Access Compliance Report

Public Rights-of-Way

(Pedestrian Signals)

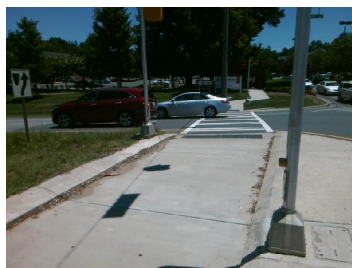
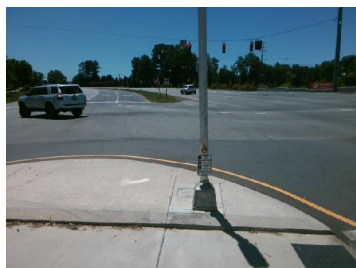
Possible Solutions: Remove and Replace Clear Space.

PROW/ADA: R404.2
